**RE: Notice of Intent (NOI) Application BETA Review Comment Response  
Franklin Bent Street  
Bent Street  
Franklin, MA 02038**

ProTerra Design Group, LLC (ProTerra) received a copy of the BETA Group, Inc. (BETA) review comments dated November 14, 2023. This letter is provided as a response to the questions and/or concerns and offer additional information in regards to the review of the “Franklin Bent Street” project located within Parcel 206-103 in Franklin, Massachusetts. Numbers below correspond to comments within the letter, and responses are in [blue](#).

# PRE-DEVELOPMENT DRAINAGE PLAN

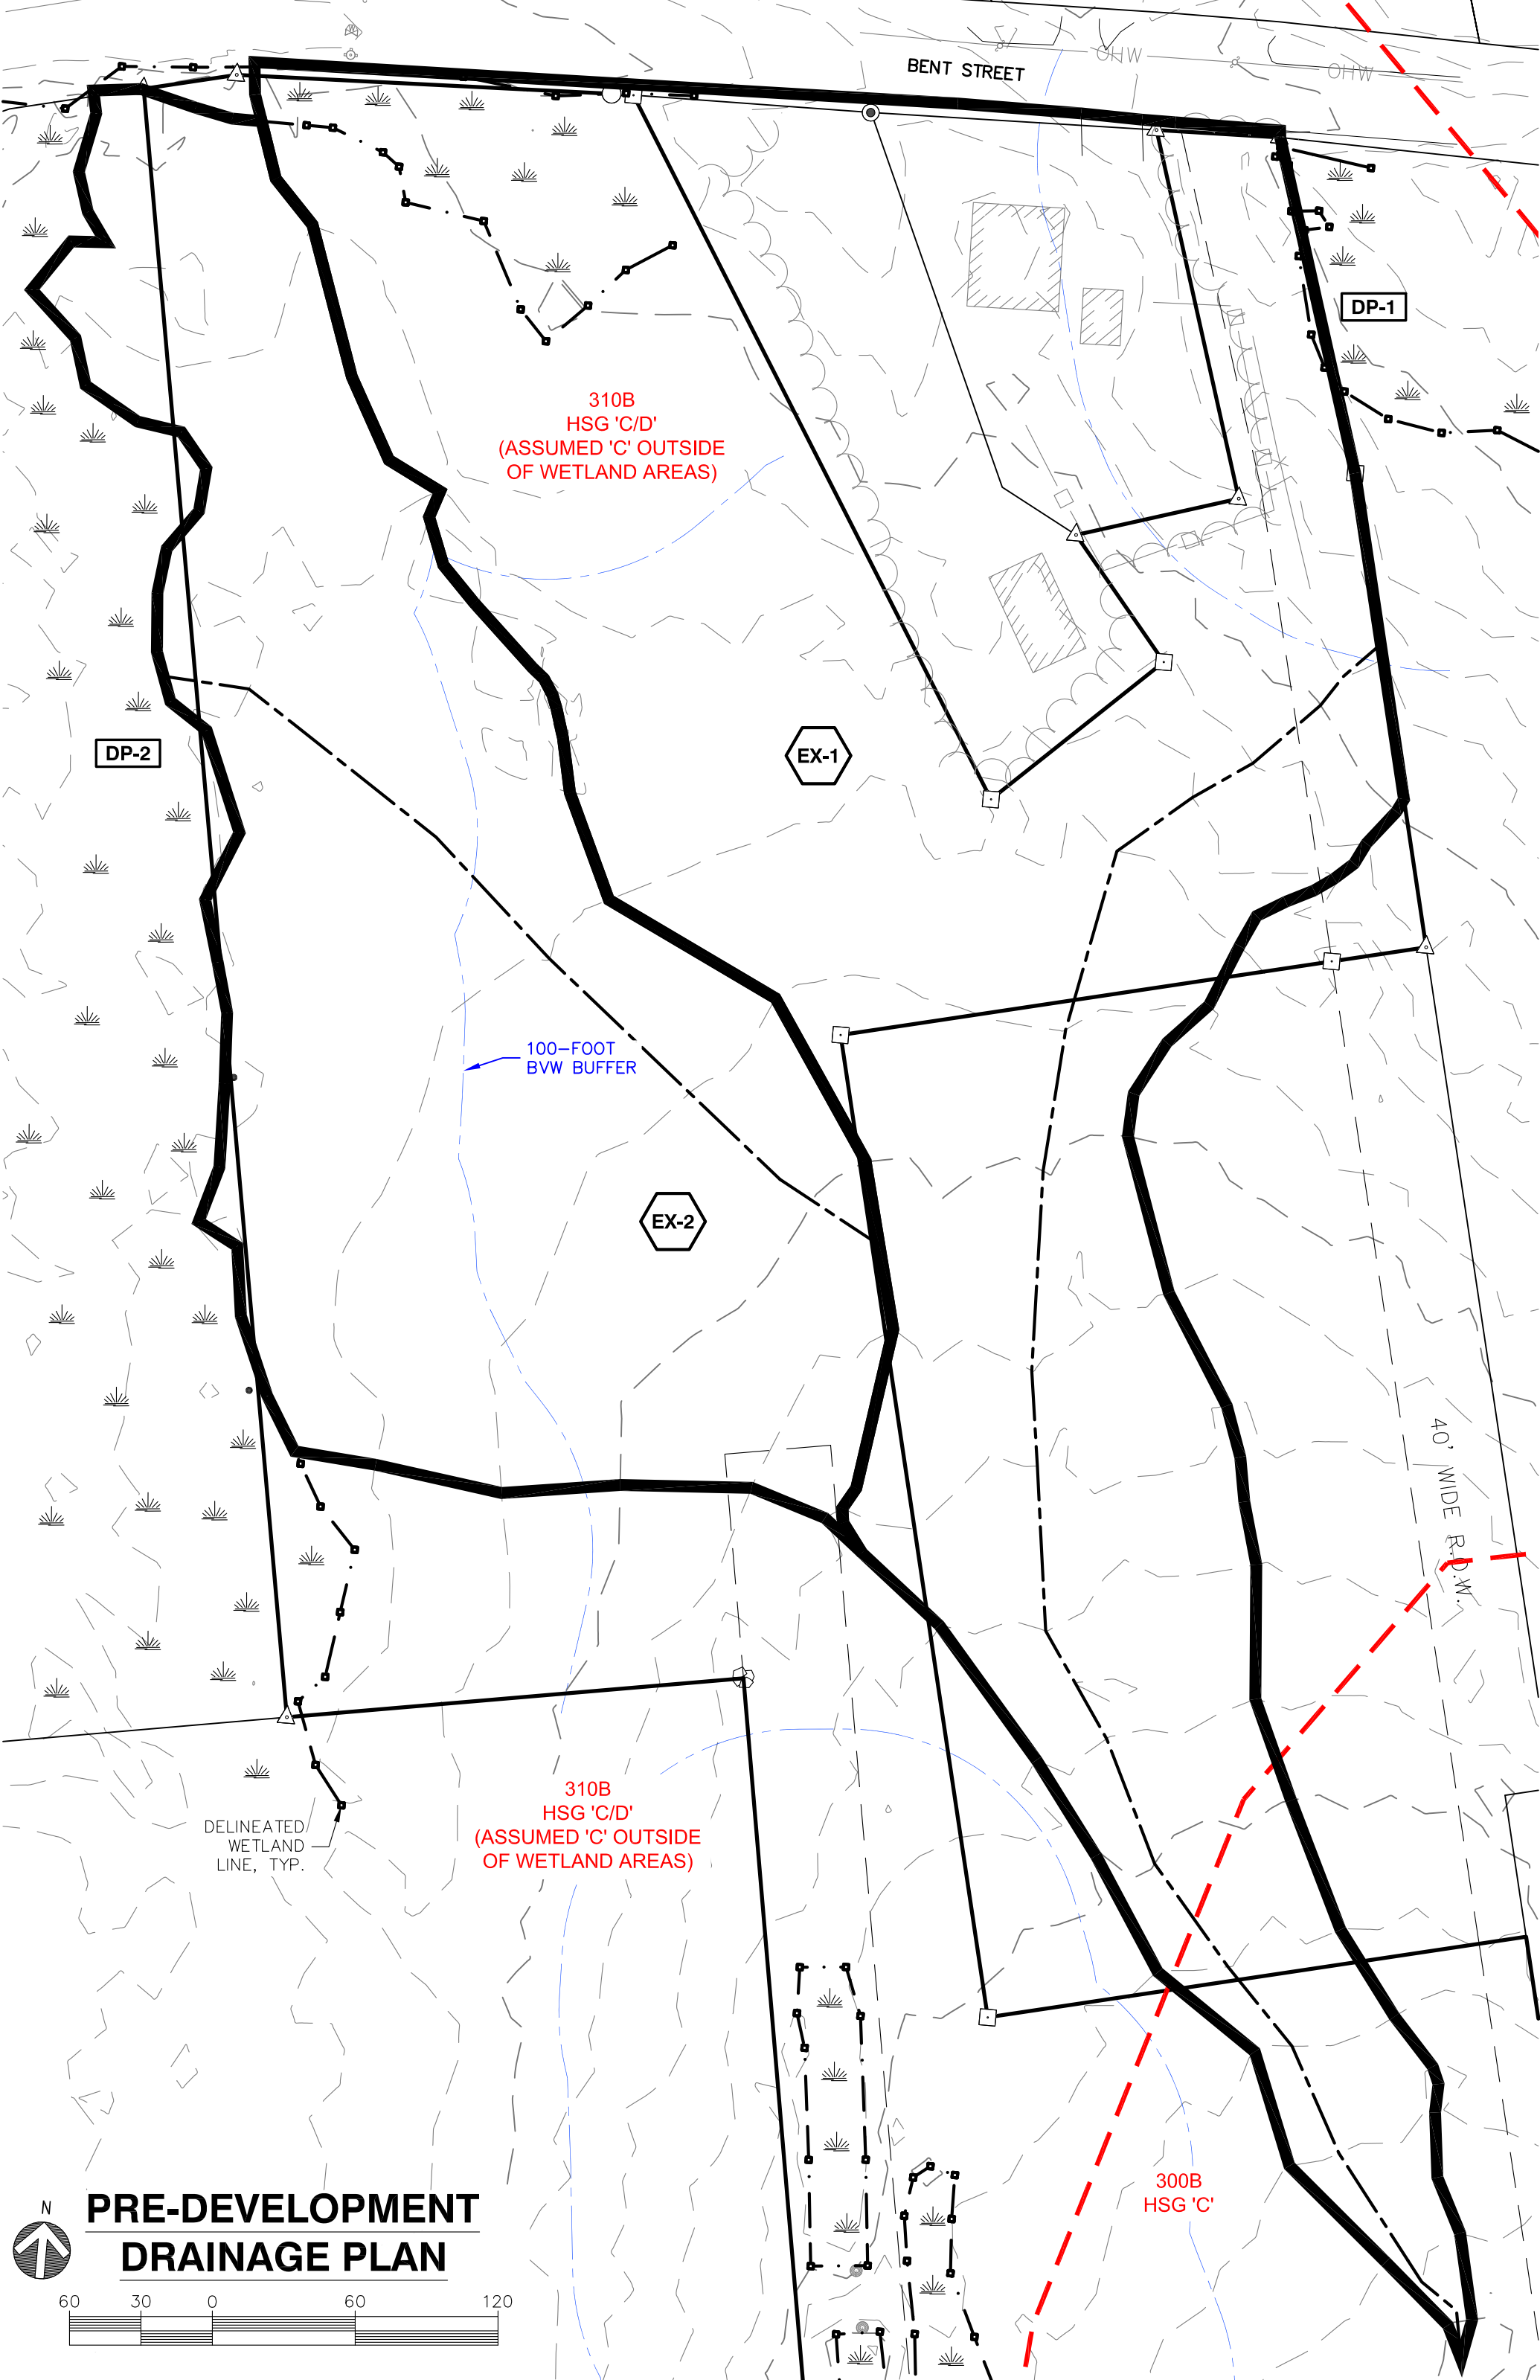
- G1. The Project summary in the HydroCAD printout should include watershed area totals to confirm that the existing and proposed conditions analysis are the same area.  
See attached HydroCAD calculations. Watershed area totals are included as requested. The total existing watershed area is 300,971 SF, and the total proposed watershed area is 300.971 SF.

- SW3. The time of concentration (Tc) calculation for the watersheds should be longest time not longest distance. BETA recommends that the Designer review flow paths.  
The time of concentration (Tc) flow paths were reviewed and adjusted as necessary. See attached Pre- and Post-Development Drainage Plans. Revised HydroCAD calculations are also attached for review.

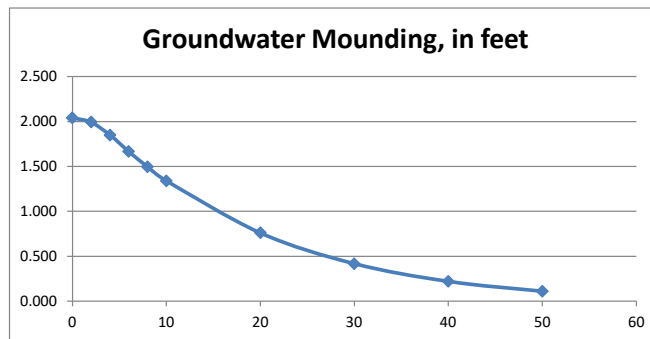
SW7. Test Pit SW-1 indicates that groundwater is present at 3.5 feet below the surface. The floor of the proposed infiltration basin is being set approximately 15 inches below existing grade. Therefore, based on the test pit results, the bottom of the basin is less than 4' above Estimated Seasonal High Groundwater. Since it is being used for both recharge and peak discharge rate control, a mounding analysis is required.

By means of the *Hantush Spreadsheet* available from the USGS, a mounding analysis was completed using the equivalent to the 10-year discarded volume within the compound basin (646 CF). By using this volume, the mounding analysis will exceed the required recharge volume provided by the compound basin.

A groundwater mounding of 2.041 FT is estimated under the compound basin. The groundwater mounding elevation at the center of the basin will reach 287.04±, and it will not breakout above the basin bottom. See attached mounding calculations.
